Seattle Urban Forestry Commission

December 13, 2018

RE: Input to Green Factor Director's Rule 2018

Chart 1 (JamesUrban.net/specifications)

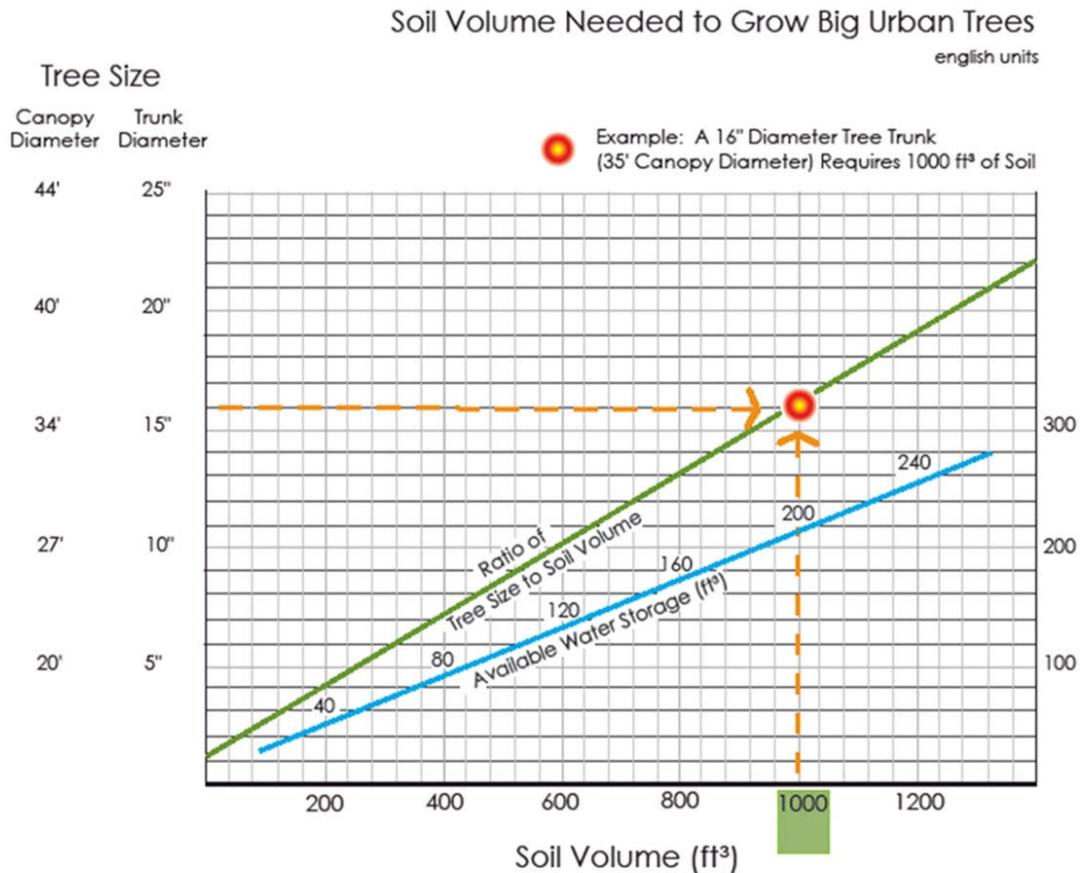
- The UFC recommends using higher soil volumes in accordance with [James Urban's recommendations](#) (in his book *Up by Roots*), particularly in street rights-of-way where soil conditions tend to be highly compacted and of poor quality. His minimum recommendation for large trees is 1,000 cubic feet (CF) of soil. Urbans' suggested soil

volumes range from 1 CF of soil per square foot (SF) of canopy (at maturity) to 3 CF of soil per SF of canopy. It is recommended that Green Factor pursue a minimum soil requirement of 2 CF per SF of tree canopy; proposed volumes under table A indicate a requirement shy of 1 CF per SF of canopy.

1,000 CF of soil is the minimum needed to properly support a mature tree with a 35' diameter canopy, which is a typical sized mature street tree when no overhead powerlines are present. Trees lacking in available growing medium (quality soil) are more susceptible to insect and fungal damage, stunted growth, shorter life spans and increased maintenance. This is most prevalent when trees are planted in 'islands' such as street trees, parking lots, and buffer plantings surrounded by adjacent imperviable surfacing.
